ADDENDUM #2

WELL #9 WATER TREATMENT FACILITY - PHASE 1 WELL AND BUILDING
CITY OF MENOMONIE
PROJECT 05323007.1
January 19, 2026

PROJECT NO.
 05323007.1
 SHEET
 05C105

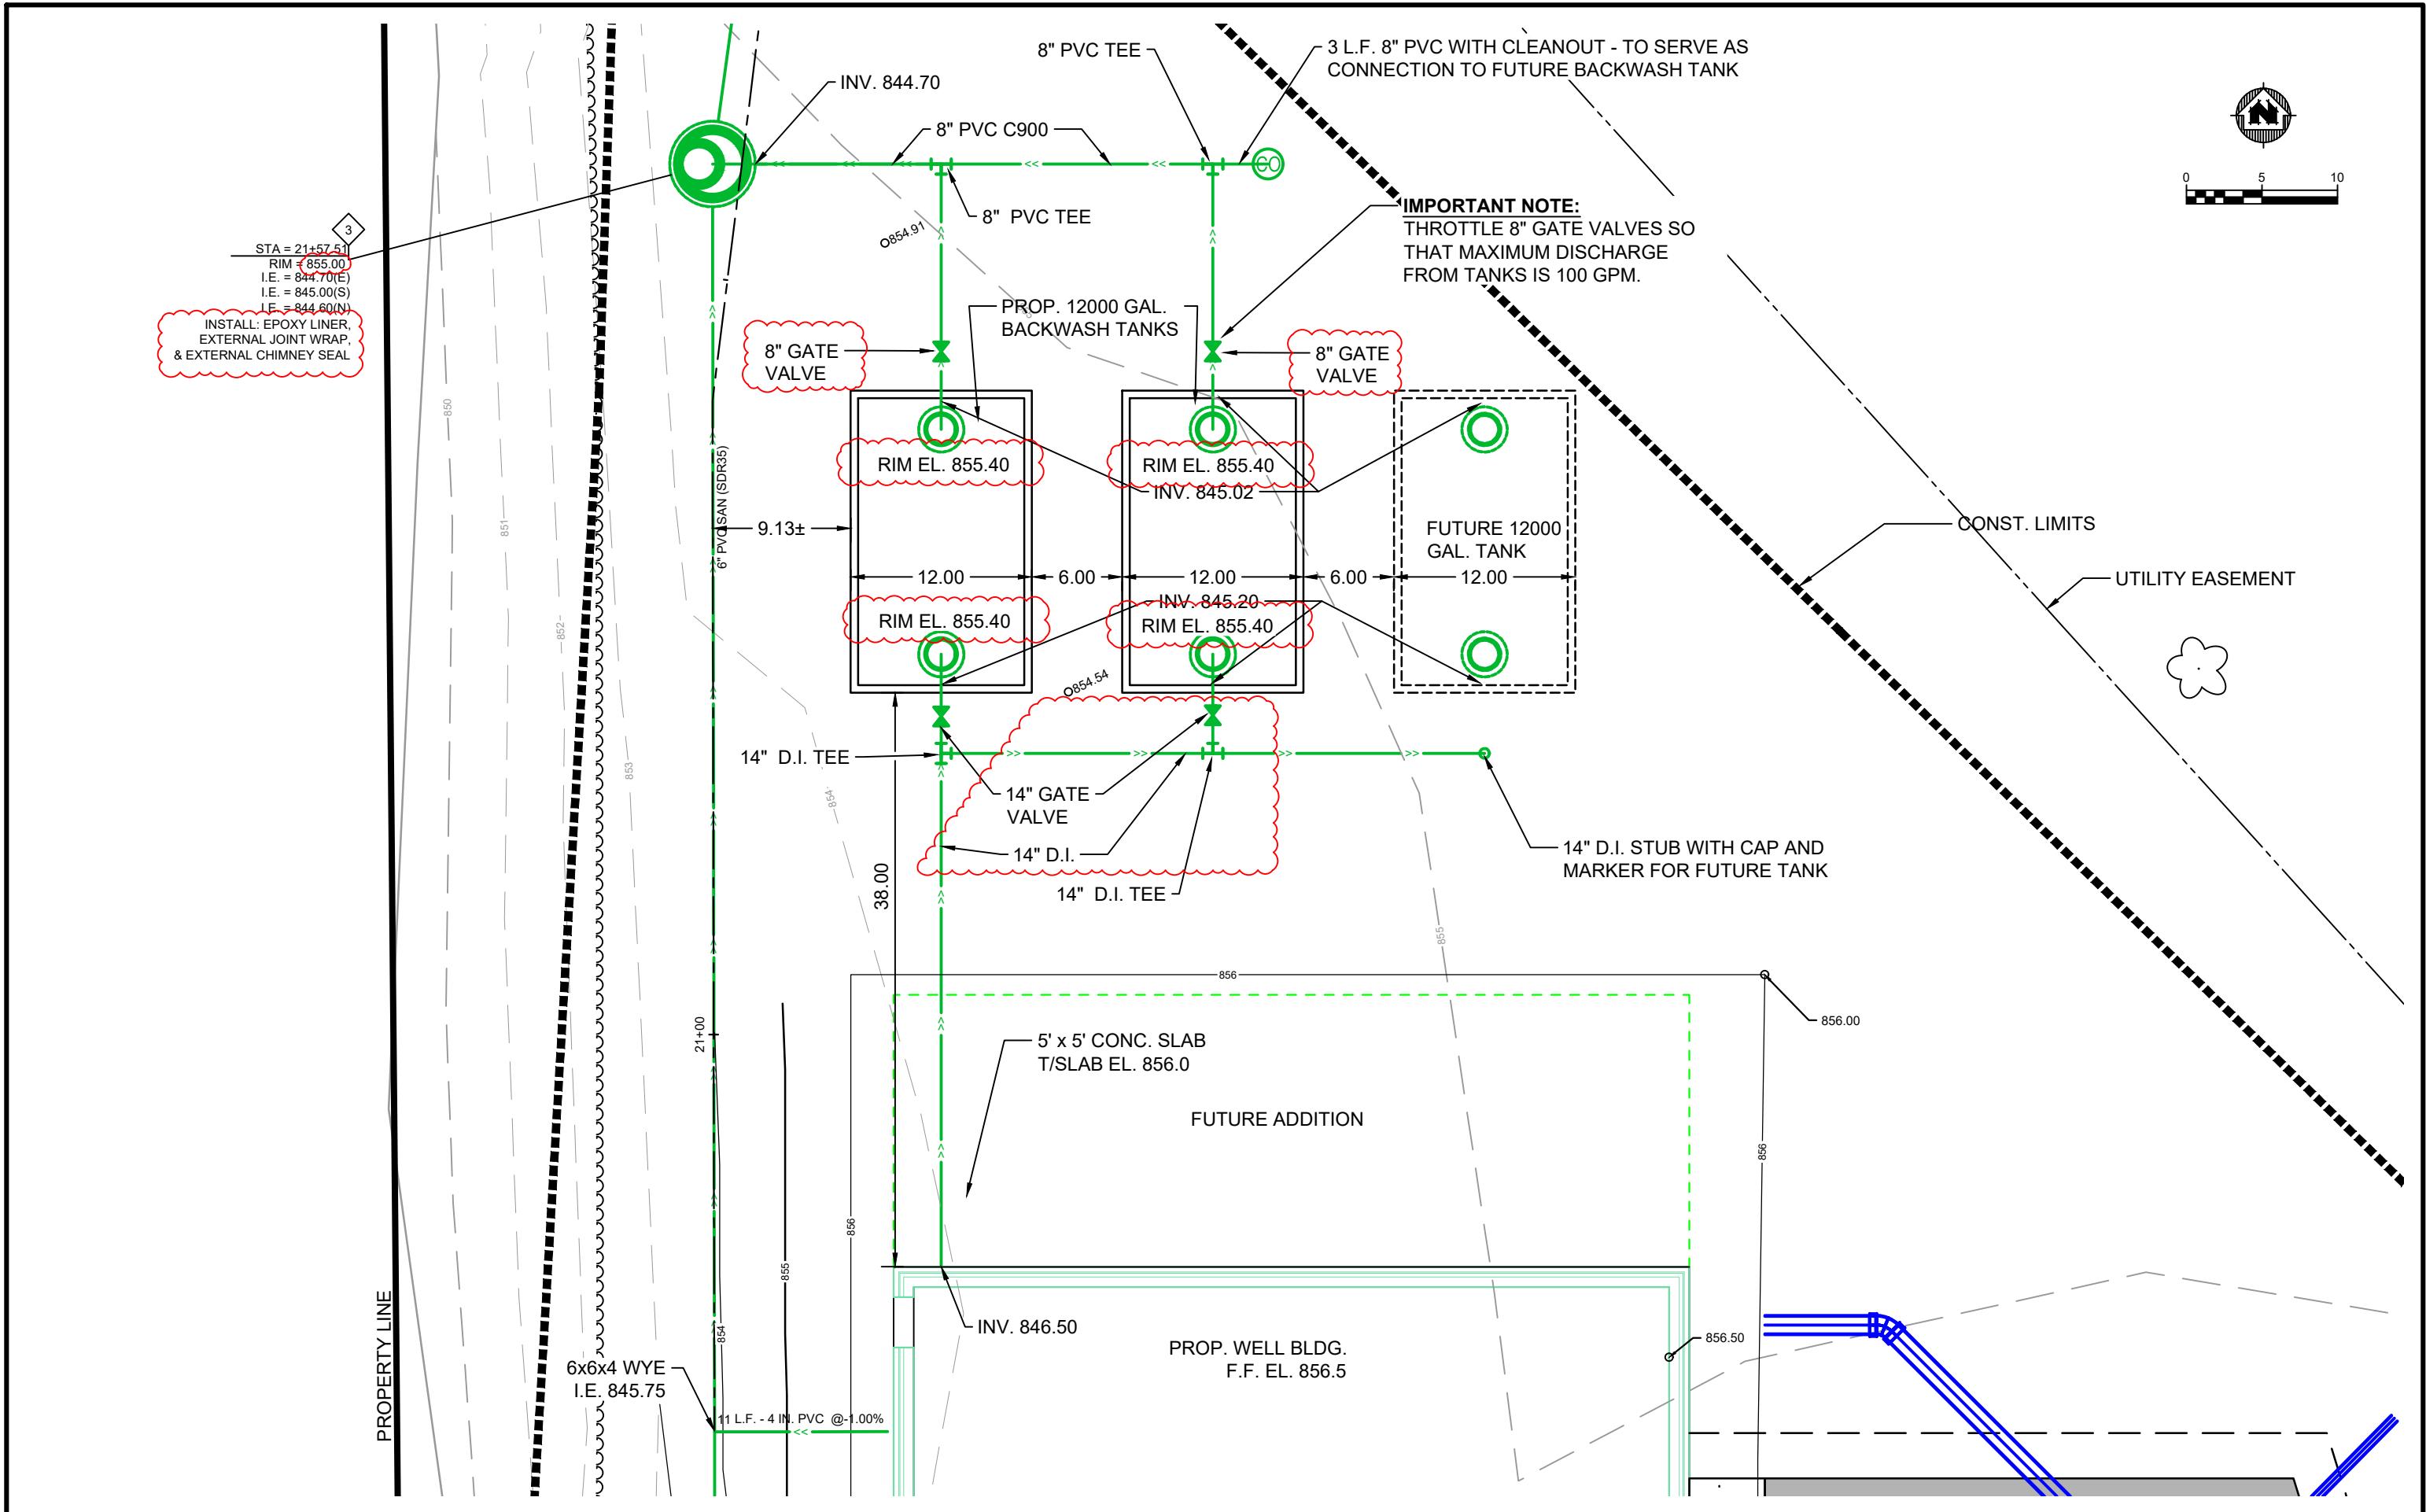
REPLACE SHEET 05C105 BACKWASH TANK PLAN, in its entirety with the attached sheet marked "Addendum No. 2".
Note: This sheet should be what is referenced in Addendum No. 1 for Sheet 05C105.

PROJECT NO.
05323007-1
SHEET
95M102

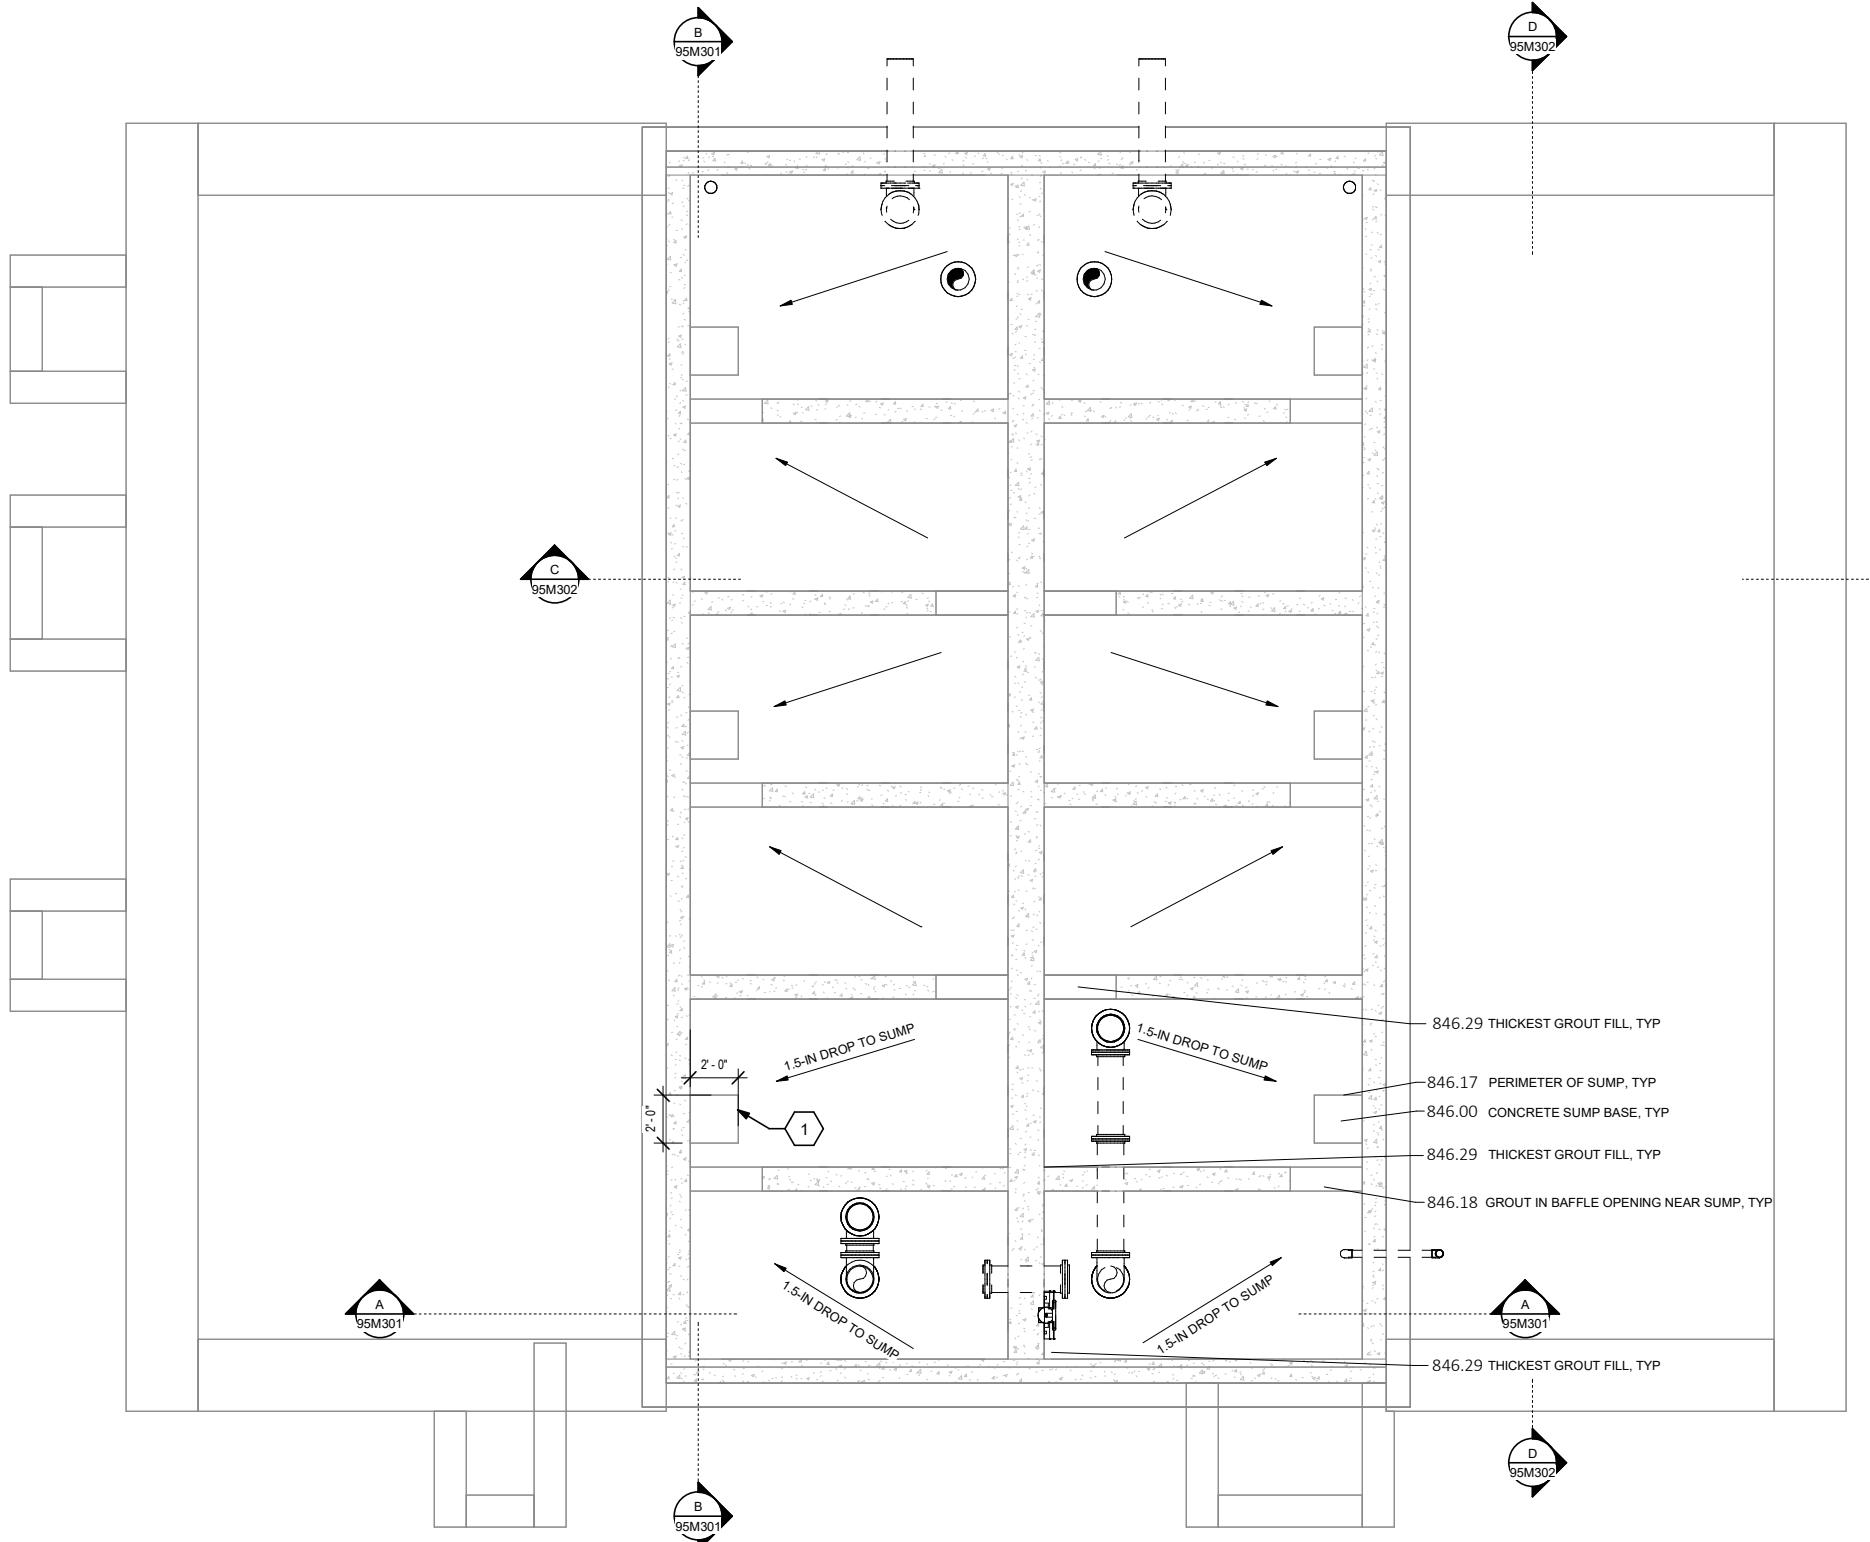
ADD Attached SHEET 95M102 DETENTION TANK PROCESS PLAN VIEW – GROUT marked "Addendum No. 2".

1
2-INCH DEEP X 2-FT WIDE X 2-FT LONG SUMP DOWN TO CONCRETE BASE. FILL GROUT AROUND SUMP FOR FLOOR SLOPE
